QC-FIT EVALUATION OF WING VALVE FAILURES

Office of Offshore
Regulatory Programs

QC-FIT Report #004
February 2017

Figure 4: Failed wing valve

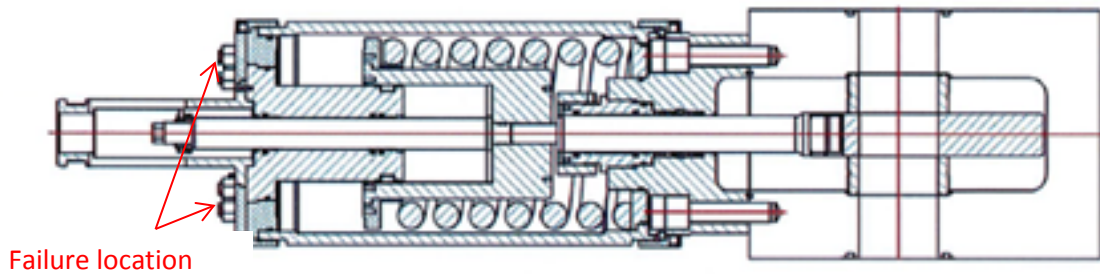
Horizontal subsea trees (Figure 3) use many of the same components as vertical trees; however, some of the equipment differs significantly from that used in vertical trees. Horizontal tree arrangements offer different benefits in regards to installation, retrieval, and maintenance. Horizontal trees may also be used with mudline suspension equipment and drill-through mudline suspension equipment and may be configured for artificial lift completions such as electric or hydraulic submersible pumps. The wing valve evaluated in this report is a failsafe valve used on a horizontal subsea tree. Figure 4 shows a schematic of the wing valve with the location of the failed fasteners.

Figure 5: Wing Valve and Terminology

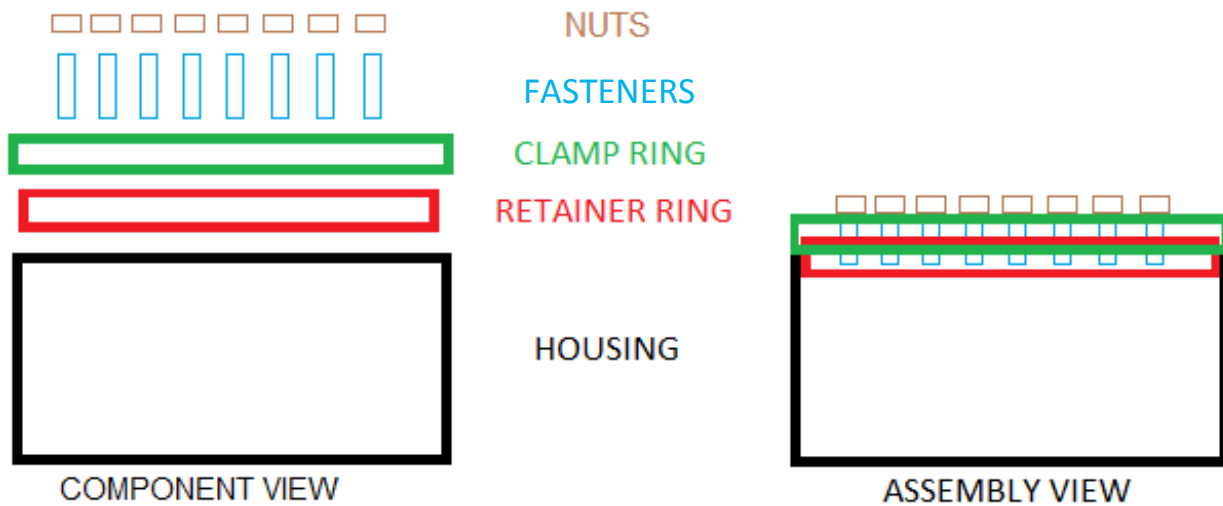
- 1) There was a large difference in the material property values between the fasteners and the retainer ring (Figure 5). The fasteners had a material yield strength value of 105 ksi, while the retainer ring's material yield strength value was 35 ksi (a difference of 70 ksi). As a result, in an over-pressurization situation, the contact area between the fasteners and retainer ring (i.e., the thread engagement of the fasteners into the retainer ring) could cause the retainer ring material to fail first. This failure would result in the retainer ring threads becoming stripped while the fasteners' threads remained intact (Figures 6 & 7). The OEM confirmed the large difference in yield strength values between the fasteners and the retainer ring. The OEM also noted that the difference in material yield strength values did not play a role in the failure because the material properties were sufficient for the anticipated load rating of the wing valve. Since the time the third party reported the incident, the OEM communicated to BSEE that the retainer ring's material yield strength value was increased. They noted that a closer match in yield strength values between the retainer ring and fasteners was a standard practice for other wing valve designs they manufacture. The new material yield strength value for the retainer ring was not provided by the OEM to BSEE. If the increase in material yield strength is not adequate, there is still a potential for hazardous failures if the fastener's threads are stripped from the retainer ring.

- 2) The amount of thread engagement between the fasteners and the retainer ring was noted. It appears there was additional space in the retainer ring for longer fasteners (which would have allowed more thread engagement). The OEM deemed that the chosen fasteners provided a "good" design safety factor with the length of thread engagement. Therefore, the OEM indicated that additional thread engagement of the fasteners into the retainer ring was not necessary for the anticipated operating loads of this wing valve design. The valve design should meet the API 6A Nineteenth Edition's thread engagement requirement to ensure that the equipment is fit for service.

1. The OEM should consider increasing the required amount of thread engagement into the retainer ring as specified in API 6A, Nineteenth Edition, and required per BSEE regulations in §250.806, to ensure proper closure bolting.

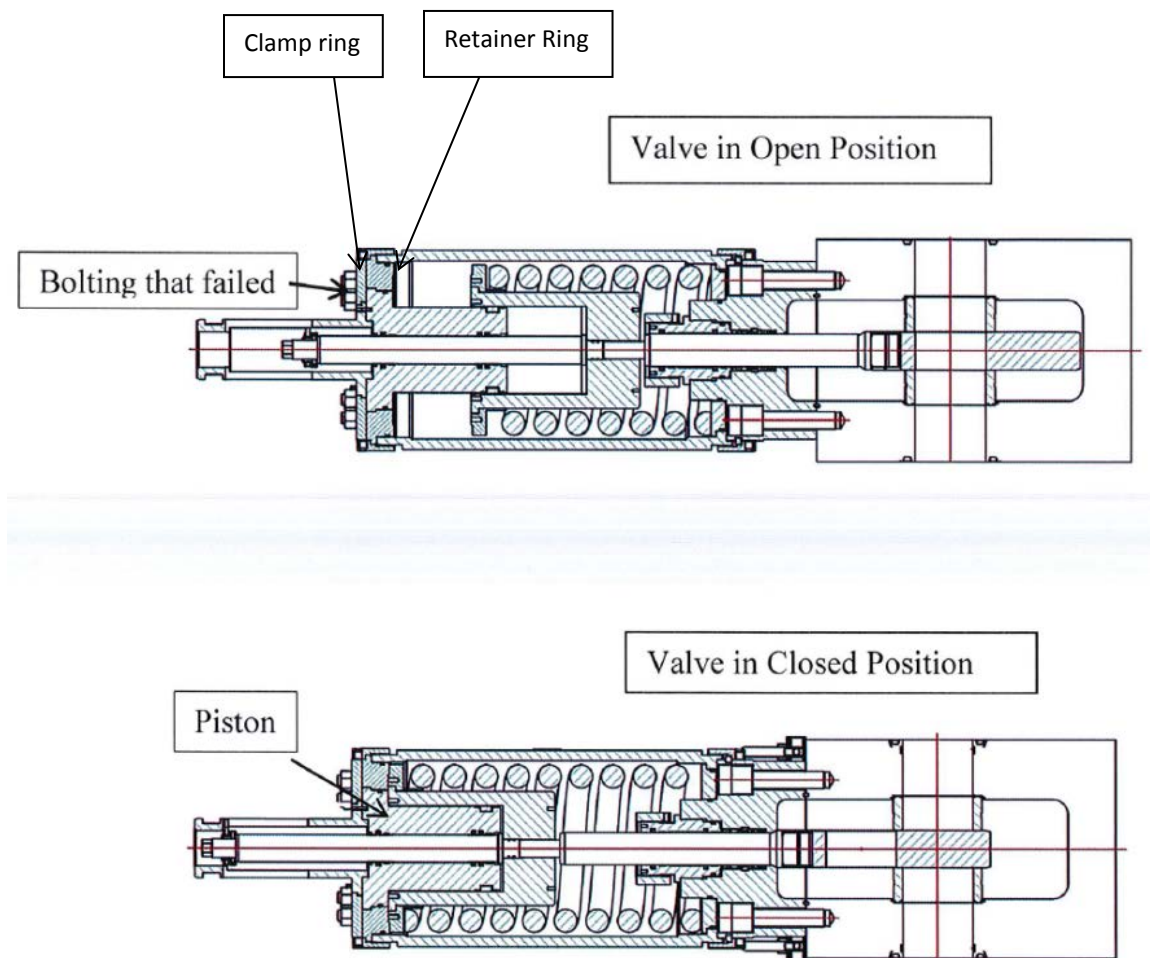
The retainer ring fits into the housing, which has threaded holes where the fasteners engage at the bottom end. The clamp ring attaches to the end (top) of the housing with through holes, which allow the fasteners to pass through. The nuts are then screwed onto the fasteners, securing the clamp ring to the housing and simultaneously securing the retainer ring inside the housing. The figure below shows an enlarged schematic view of these components and the assembled view.
